PROJECT: **AHU REPLACEMENT AT SYLVANIE WILLIAMS ELEMENTARY
SCHOOL
RSD PROJECT # 2011-0876-0001
3127 Martin Luther King Jr. Blvd.
New Orleans, LA 70125**

ENGINEER: **IMS Engineers, P.A.
126 East Amite Street
Jackson, MS 39201**

END OF ADDENDUM NO. 1

POWER VENTILATOR SCHEDULE

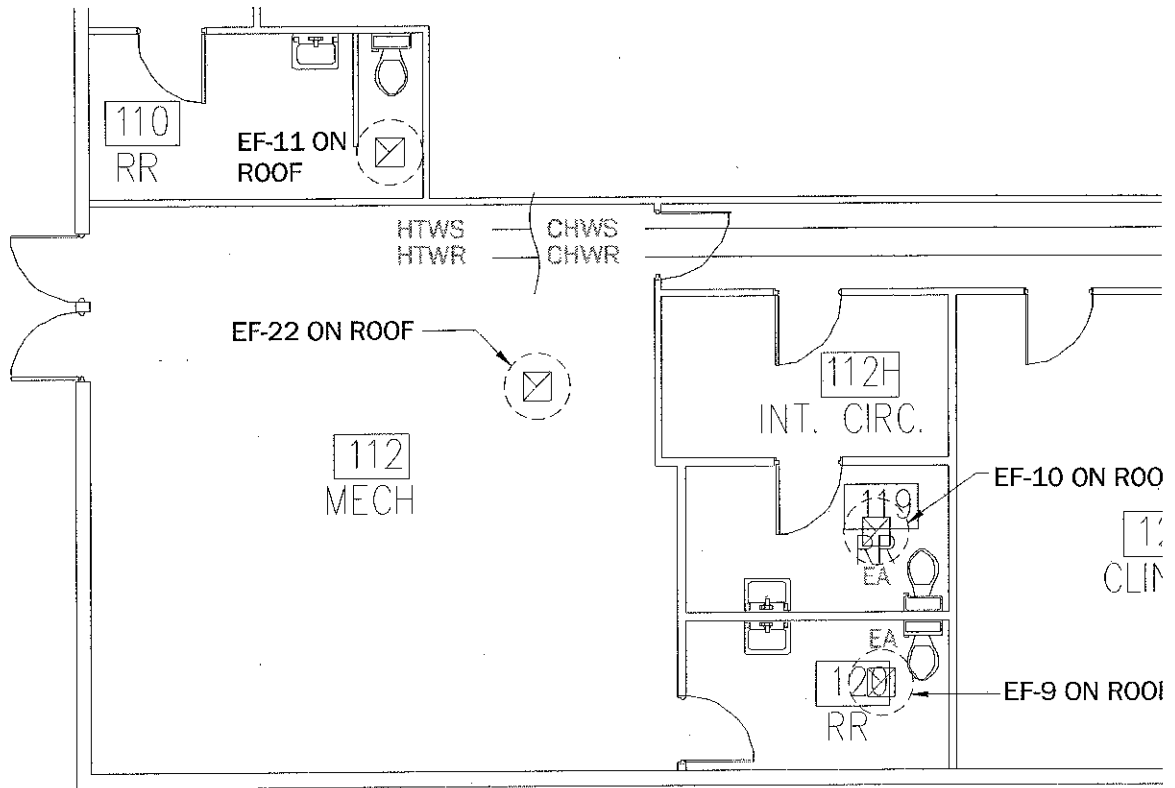
A. Replace existing sheet Power Ventilator Schedule, Sheet M0.2, with the attached Power Ventilator Schedule (boiler room roof mounted exhaust fan).

108 STOR	150	0.13	1/30	115/1	1050	666	0.8	ROOF	CENTRIF	DIRECT	40	1,2,3,4,5,6,7,8,9
100D RR	50	0.13	1/60	115/1	1550	966	1.1	ROOF	CENTRIF	DIRECT	32	1,2,3,4,5,6,7,8,9
100B RR	50	0.13	1/60	115/1	1550	966	1.1	ROOF	CENTRIF	DIRECT	32	1,2,3,4,5,6,7,8,9
209A RR	50	0.20	1/6	115/1	1140	695	1.6	ROOF	CENTRIF	DIRECT	68	1,2,3,4,5,6,7,8,9
209B RR	50	0.20	1/6	115/1	1140	695	1.6	ROOF	CENTRIF	DIRECT	68	1,2,3,4,5,6,7,8,9
318 RR	50	0.13	1/60	115/1	1550	966	1.1	ROOF	CENTRIF	DIRECT	32	1,2,3,4,5,6,7,8,9
319 RR	50	0.13	1/60	115/1	1550	966	1.1	ROOF	CENTRIF	DIRECT	32	1,2,3,4,5,6,7,8,9
25 RR,215 RR,303A RR	650	0.20	1/8	115/1	860	733	4.2	ROOF	CENTRIF	DIRECT	71	1,2,3,4,5,6,7,8,9
24 RR,214 RR,302A RR	650	0.20	1/8	115/1	860	733	4.2	ROOF	CENTRIF	DIRECT	71	1,2,3,4,5,6,7,8,9
12B CUST,312B CUST	125	0.20	1/6	115/1	1140	877	2.9	ROOF	CENTRIF	DIRECT	68	1,2,3,4,5,6,7,8,9
BOILER ROOM	1,540	0.25	1/4	115/1	1540	704	6.9	ROOF	CENTRIF	DIRECT	58	1,2,3,4,5,6,7,8,9,10
